VIRGINIA ELECTRIC AND POWER COMPANY  
RICHMOND, VIRGINIA 23261

**VIRGINIA ELECTRIC AND POWER COMPANY (DOMINION)**  
**NORTH ANNA POWER STATION UNITS 1 AND 2**  
**NORTH ANNA INDEPENDENT SPENT FUEL STORAGE INSTALLATION**  
**REVISION TO NORTH ANNA POWER STATION EMERGENCY PLAN**

**ATTACHMENT 2**  
**NORTH ANNA EMERGENCY PLAN REVISION 29 SUMMARY**

FIGURE 7.2

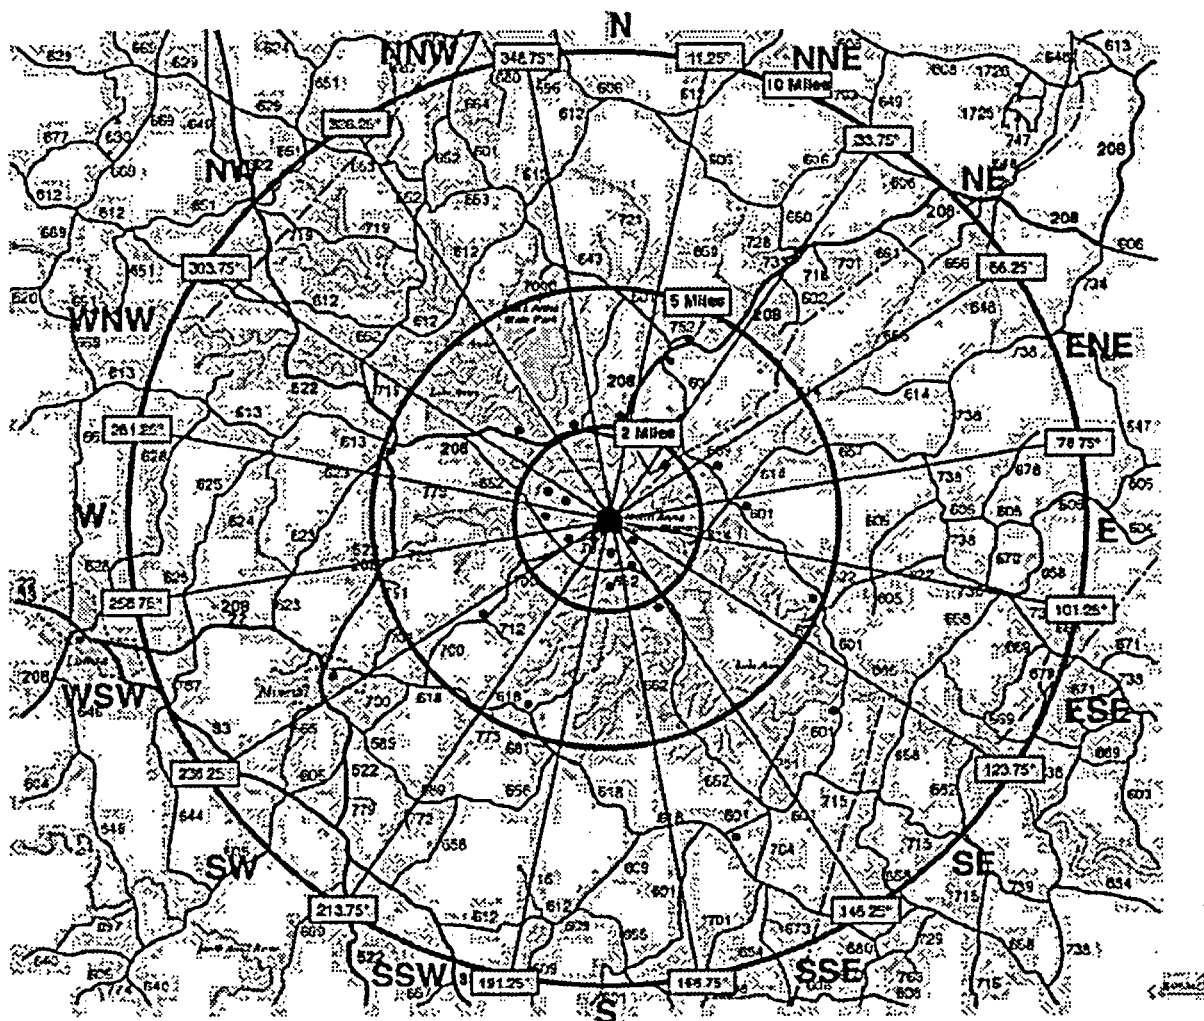
- 4     Updated list of environmental monitoring locations and reference to the associated source document (VPAP-2103N, Offsite Dose Calculation Manual (North Anna), Revision 6) in Figure 7.2, North Anna Power Station Monitoring Location Listing.

- Updated Table 7.1, Emergency Response Facility Communications, to delete obsolete circuit.
- Updated Figure 7.2, North Anna Power Station, Monitoring Location Listing, to reflect current version of its source document and its contents.
